PURCHASER'S EXTRAS QUOTATION

Bayview Heights - Phase 1

LOT NUMBER	PHASE	HOUSE TYPE
050 BLOCK 008	1	THE CHARLOTTE-ELEV C-STD MAIN-3 BDRM-3 BATHS

BLK. 8 TH. 50 20-16 THE CHARLOTTE EL. C 3 BDRM. 3 BATH. 1795 SQ. FT.

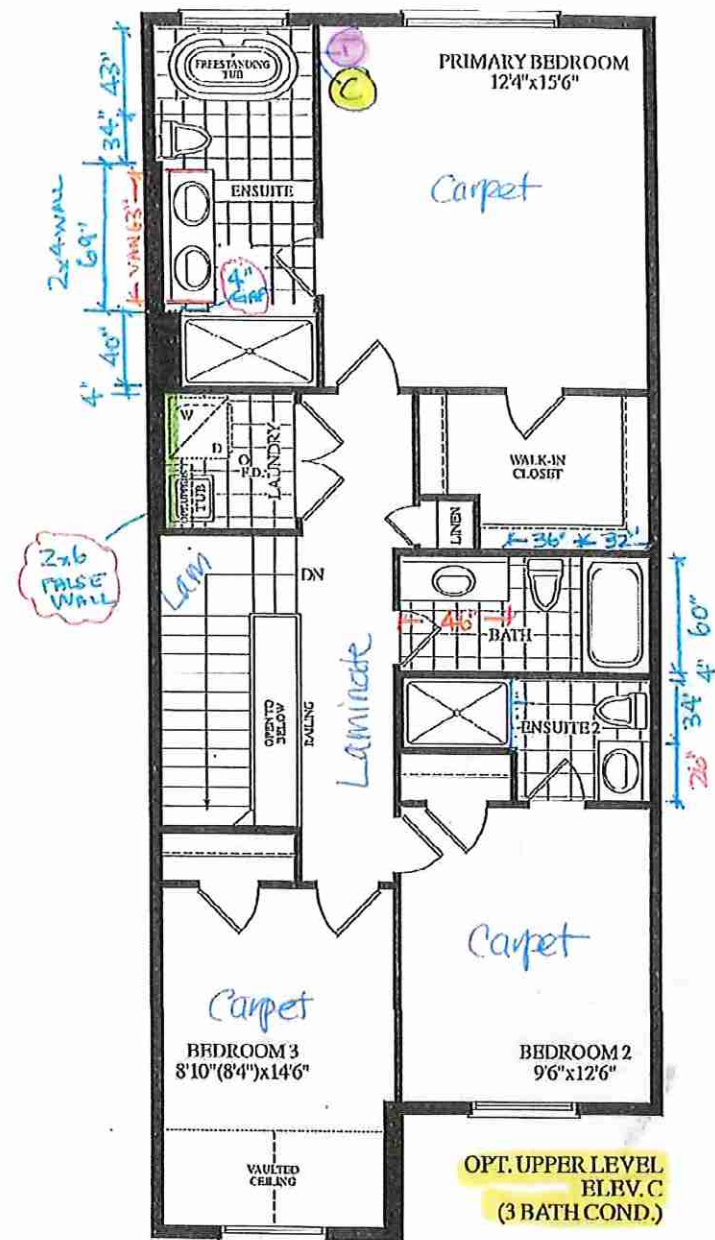
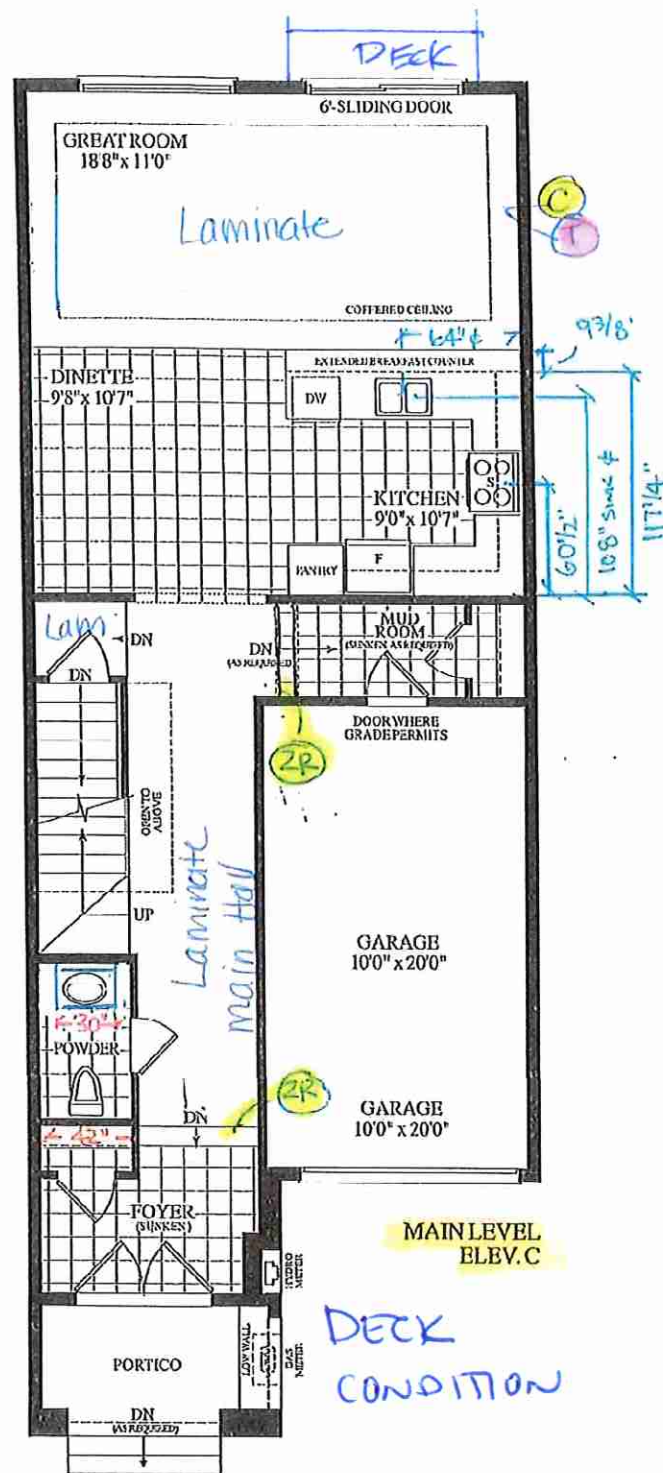
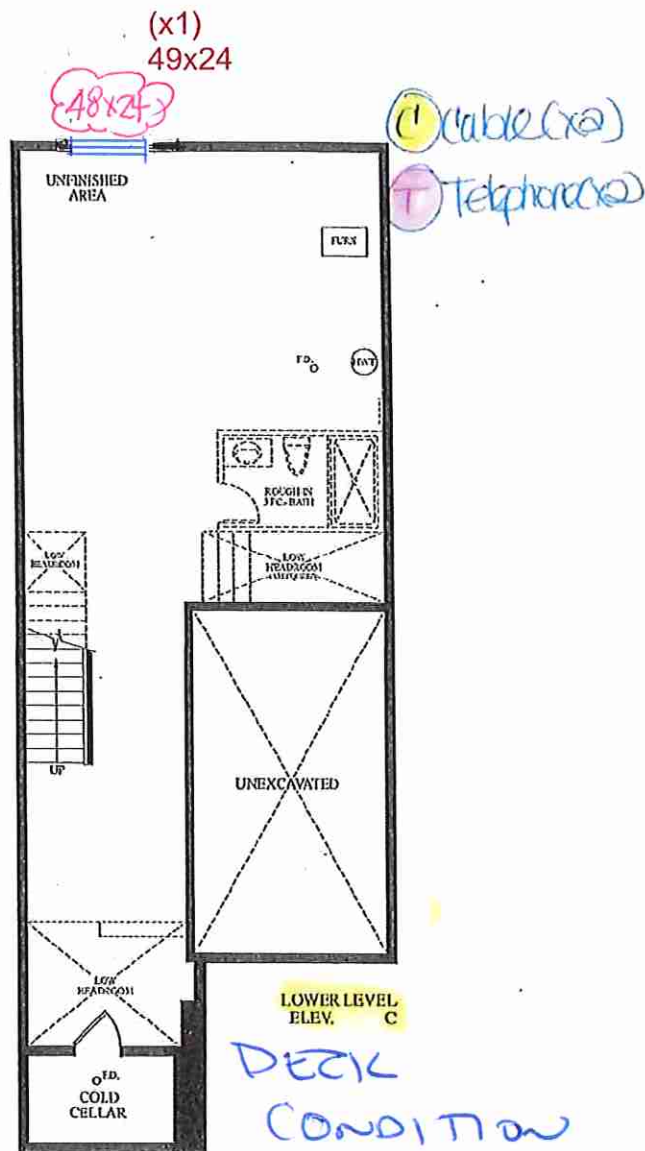
ITEM	EXTRA / CHANGE	QTY	UNIT PRICE	EXTENDED
1	BASEMENT-Delete the TWO standard 30x16" windows at the back of home and install ONE large 48"x24" (49"x24" R/O) basement window (with possible window well)(See Sketch)	1	\$0.00	\$0.00
237705	As per Fonzie			
2	PURCHASER AWARE AND ACCEPTS THAT ANY CHANGES MADE TO UPGRADES AFTER SIGNING THIS PURCHASERS EXTRA FORM ARE SUBJECT TO A MINIMUM ADMINISTRATION FEE OF \$1,000	1	\$0.00	\$0.00
237706

ENSUITE PLAN

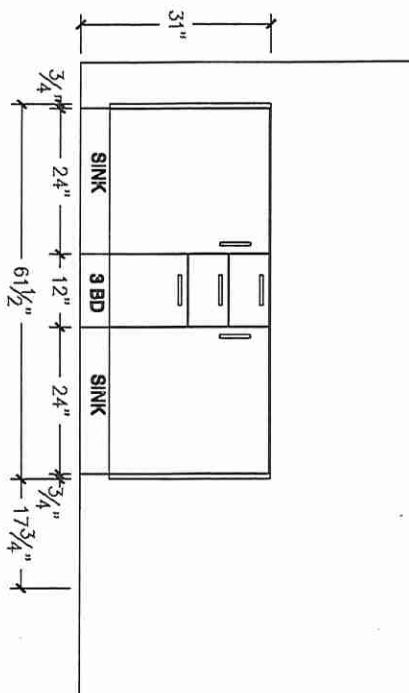
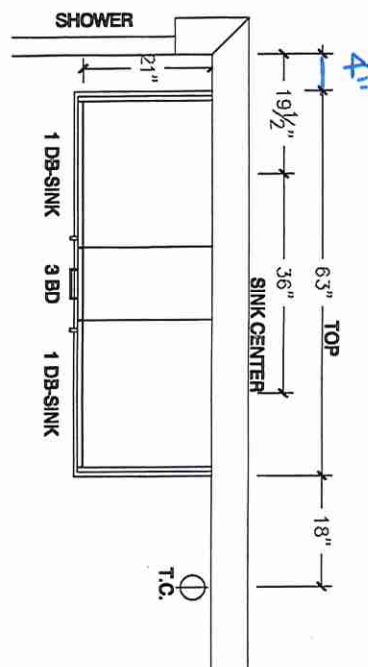
1 - PRIMARY ENSUITE- Purchaser accepts and acknowledges the change made to teh Primary Ensuite reloaction of the vanity, toilet and door relocation (See Sketch)
Note:
